Appendix C

Complete set of RFIs submitted to TII

Doc. No. P0027301-1-H3 Rev. 0 - September 2022

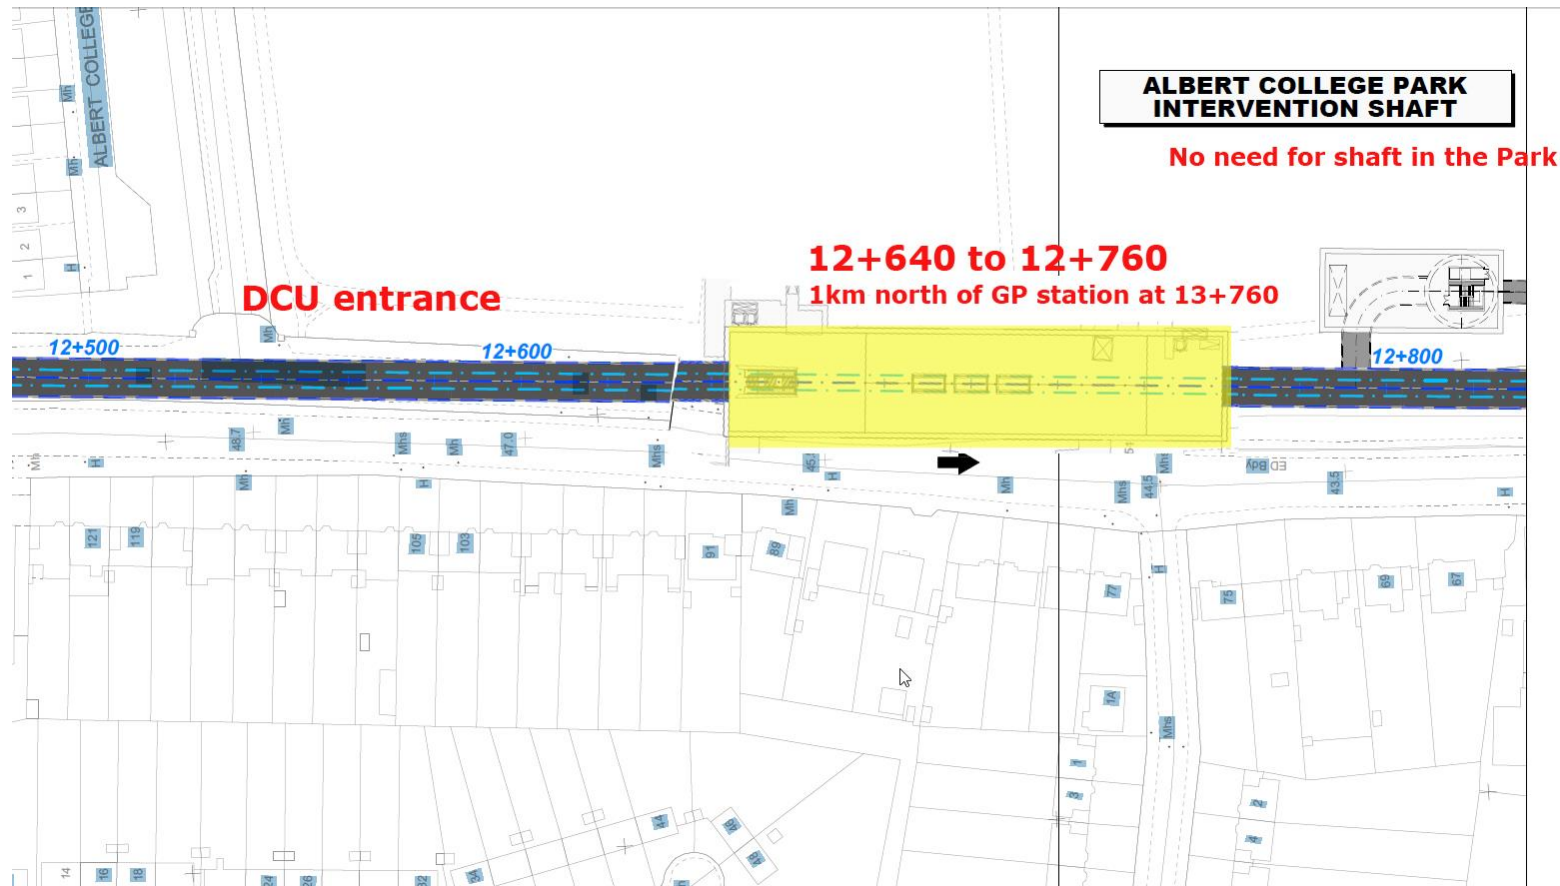
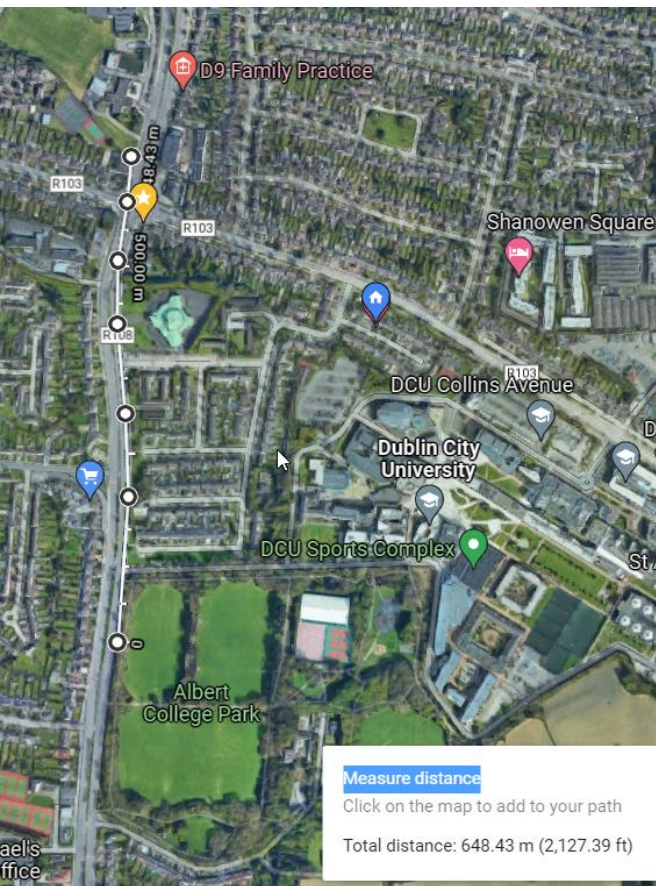
Locating the Station box 12+640 to 12+760 would do away with the intervention shaft in the park and meet the required 1km distance north of the Griffith Park Station Box. The shaft ideally would be located at 11+950 site beside the Ballymun Library, north of the busy Collins Ave, Glasnevin Ave and Ballymun Road junction.

- ✓ *In your proposal, how far is Collins Avenue Station from Ballymun Station (platform ends)?*
 - *Not fully sure, currently less than 1km, I think around 800 metres. Moving the Church Station to the Park will make the distance greater than the 1km and hence the need for*

a shaft and the library location is preferred as it is north of the busy junction of Collins Ave.

Figure 1.

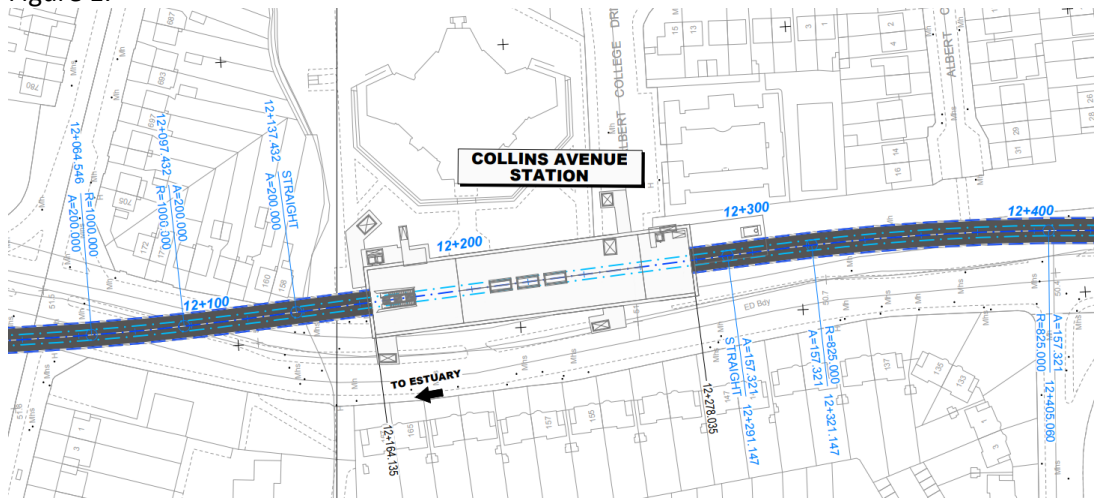
TII's current proposed Church location at 12+164 is 125 metres south of Collins Ave (2 minute walk) and 360 metres north of the DCU main gate. Figure 1.

Figure 2. Our proposed Park Station location.

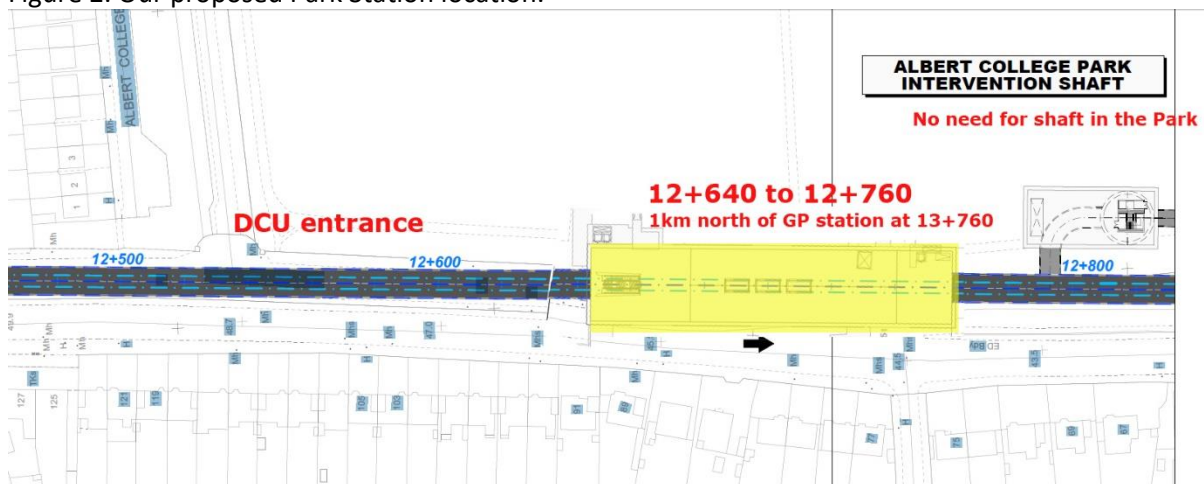
Whilst our proposed Park Station Figure 2 below would be a further 400 metres (5minute walk) south of the current Church station location we would question the premise that an extra 5 minute walk would reduce footfall to such a degree given the vast majority of users of the station would be from DCU and the future housing developments located nearby.
